SAWMILL CREEK ADDITION

RE: S/D 99-87 -- Final Plat of SAWMILL CREEK ADDITION

RE: S/D 99-87 -- Final Plat of SAWMILL CREEK ADDITION

CASE NUMBER: S/D 99-87 -- SAWMILL CREEK ADDITION

SAWMILL CREEK ADDITION

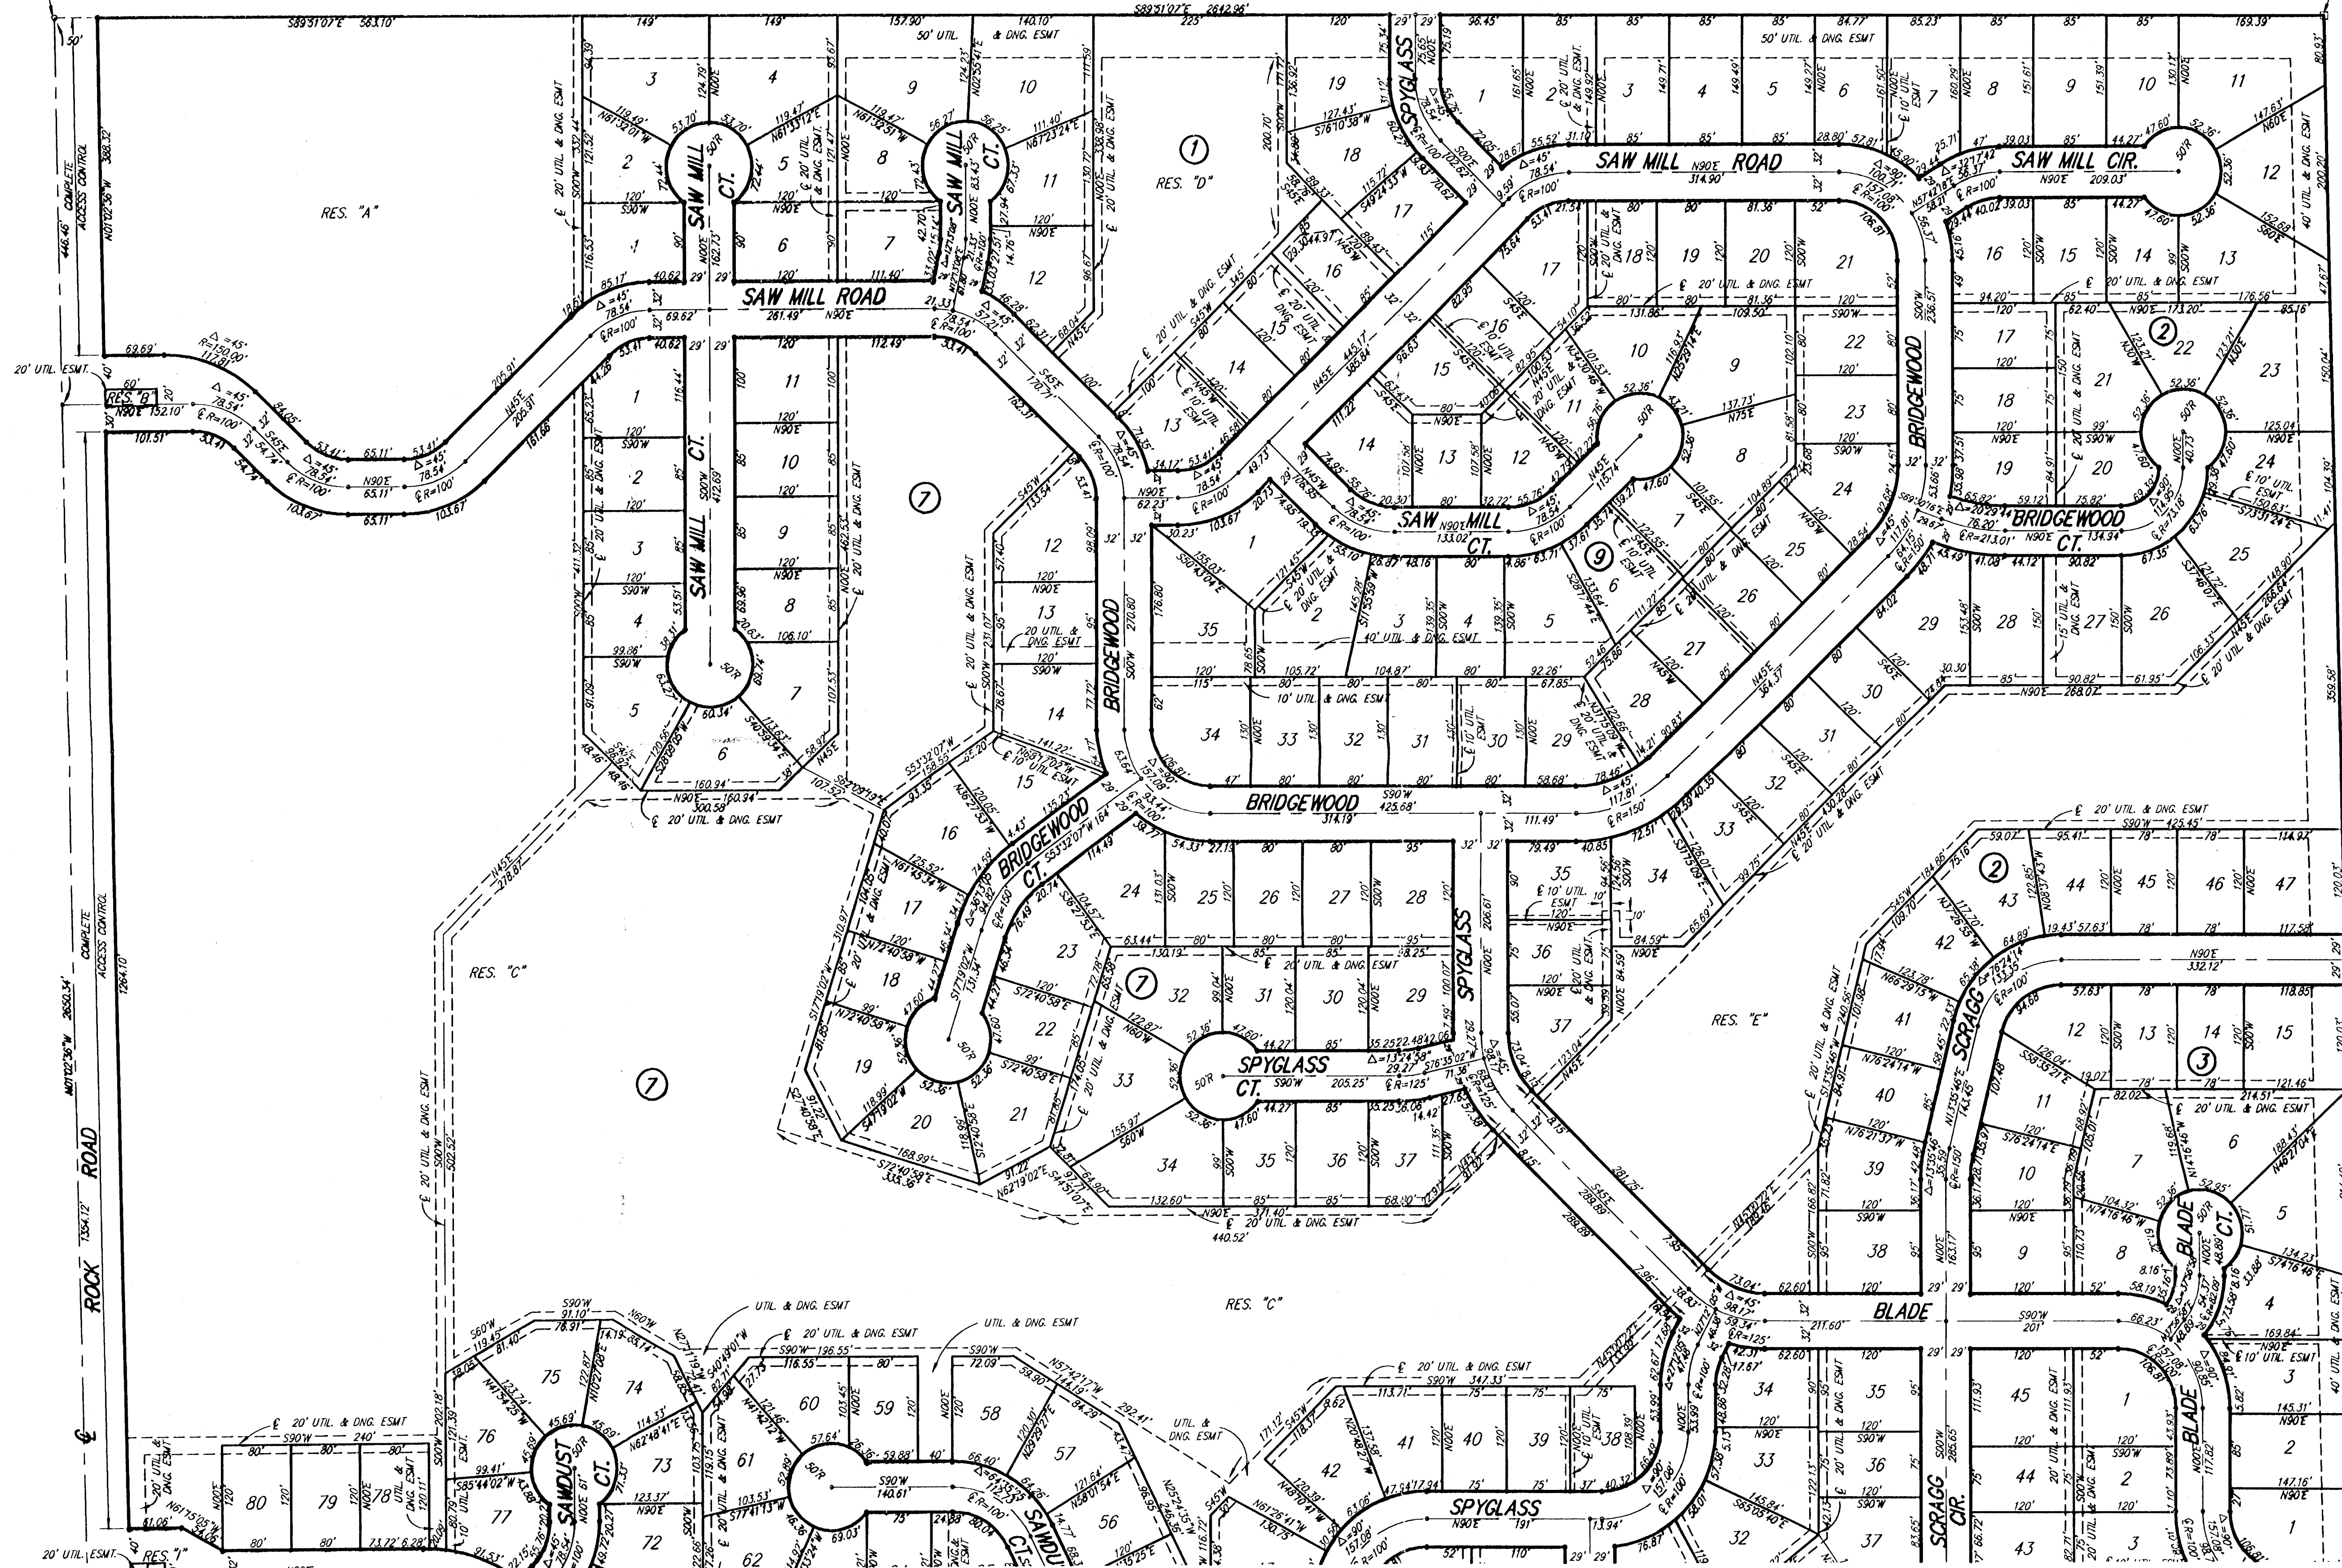
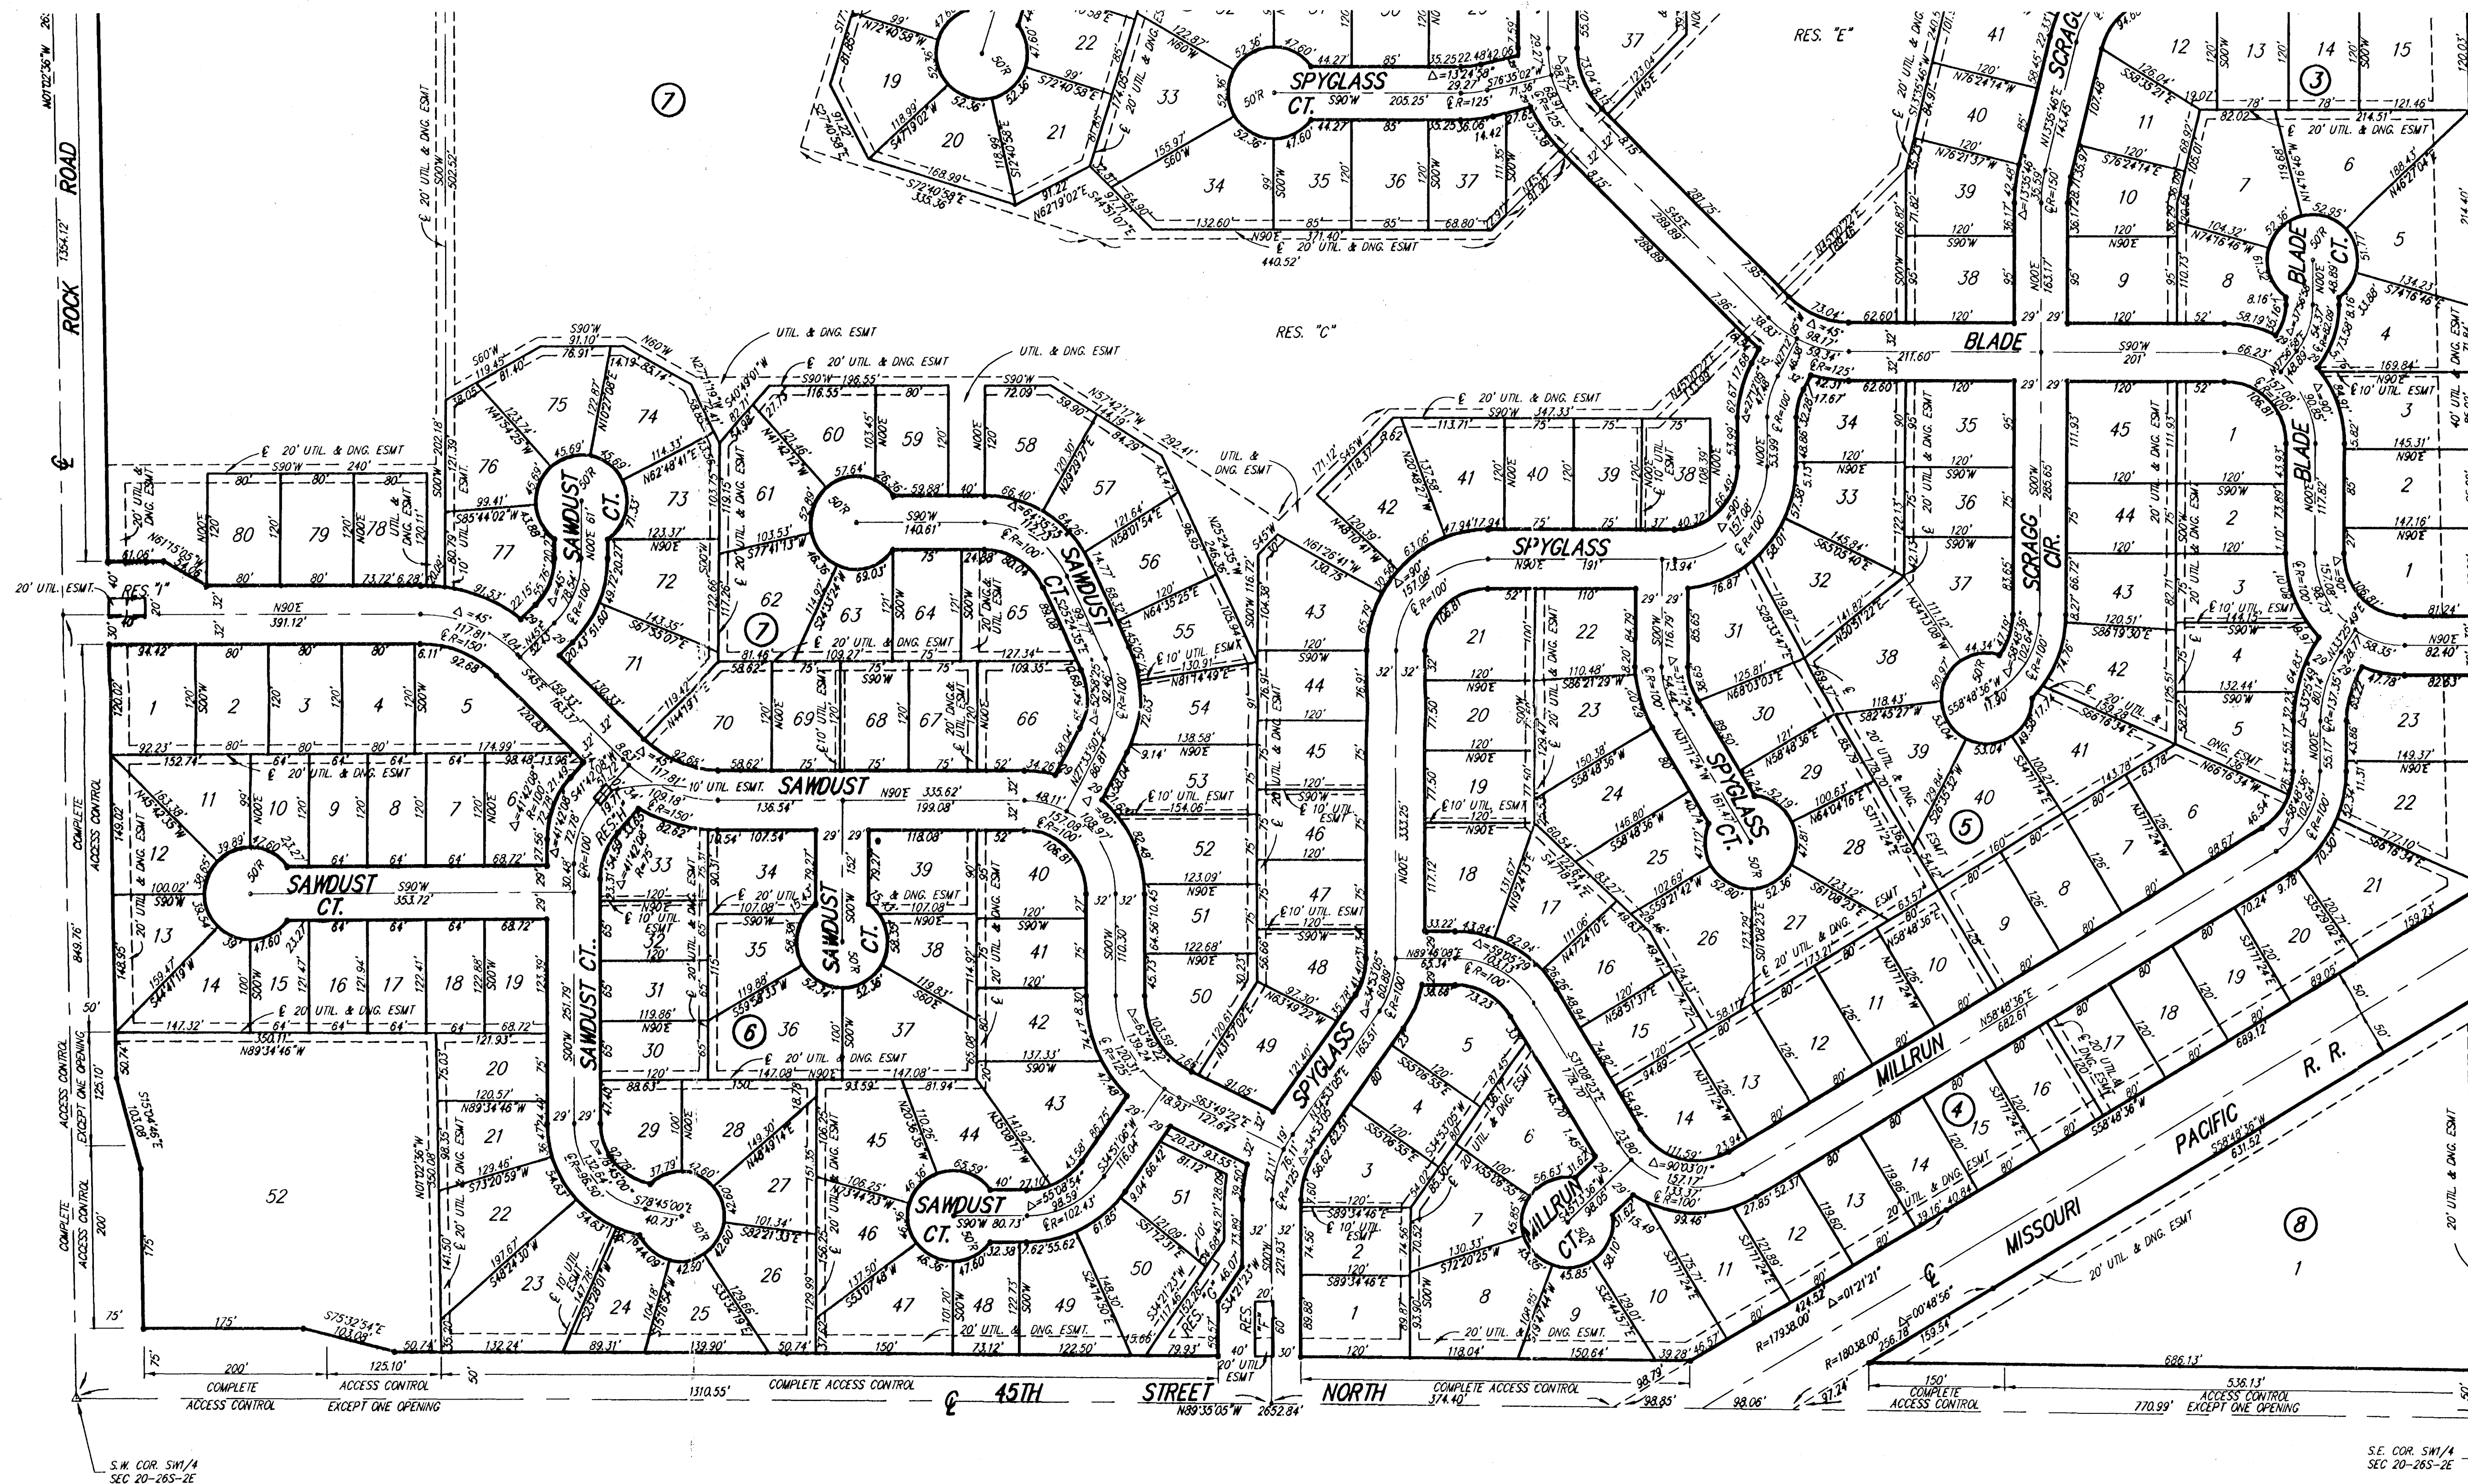
- A. City Engineering needs to comment on the need for guarantees or easements. The applicant shall provide a guarantee for the extension of municipal water and sewer. **A sewer layout is requested. An off-site sewer easement is needed. Utility easements shall be added to Lot 1, Block 8.**

- D. City/County Engineering needs to comment on the status of the applicant's drainage plan. **County Engineering requests a drainage plan for review. The minimum pad elevations need elevations. City Engineering has approved the drainage plan. A drainage guarantee is required.**

- H. The right-of-way widths for perimeter streets shall be denoted.
- I. Provisions shall be made for ownership and maintenance of the proposed reserves. The applicant shall either form a lot owners' association prior to recording the plat or shall submit a covenant stating when the association will be formed, when the reserves will be deeded to the association and who is to own and maintain the reserves prior to the association taking over those responsibilities.

- O. The benchmark elevations should be checked.
- P. Reserve B needs to be located.
- Q. Road rights-of-way near Reserve B, Reserve F, Reserve H, and Reserve I need to be dimensioned.

- R. Curve data at the west end of Saw Mill Road on the north side needs to be labeled.
- S. The utility and drainage easement labeled on Lot 9, Block 1, needs to be changed to 40 feet.

- T. The following items need to be labeled: easements on Lot 13, Block 7; Lot 27, Block 2; Lots 29-34, Block 7; road right-of-way on the northwest corner of the plat; curve data near

Reserve H on the east and west sides of the road; property line information on Reserve G; point of intersection (P.I.) on Lot 14, Block 4 bearing southwesterly; P.I. on the northwest line of Lot 1, Block 8 bearing southwesterly; and widths of Access Control along Lot 1, Block 8 and Lot 52, Block 6.

- U. The following items need to be located: easement in Reserve C near Lot 16, Block 7; easement on Lot 38, Block 5; easement in Reserve C near Lot 38, Block 7; easement in Reserve E near Lots 38 and 39, Block 2;

- V. Reserve H needs to be dimensioned.
- W. The applicant shall submit a covenant which provides for four (4) off-street parking spaces per dwelling unit on each lot which abuts a 58-foot street. The covenant shall inventory the affected lots by lot and block number and shall state that the covenant runs with the land and is binding on future owners and assigns.

FF. The representatives from the utility companies should be prepared to comment on the need for any additional utility easements to be platted on this property. **Southwestern Bell and KGE have requested additional easements.**

- The final plat has included the requested access strips.
- L. Additional street stubs should be platted to the north or to the north and east for increased mobility when development occurs in these locations.

- The applicant has included two street stubs to the east and one stub to the north.
- M. Traffic Engineering should comment on the need for improvements to perimeter streets. A guarantee shall be provided for decel lanes.
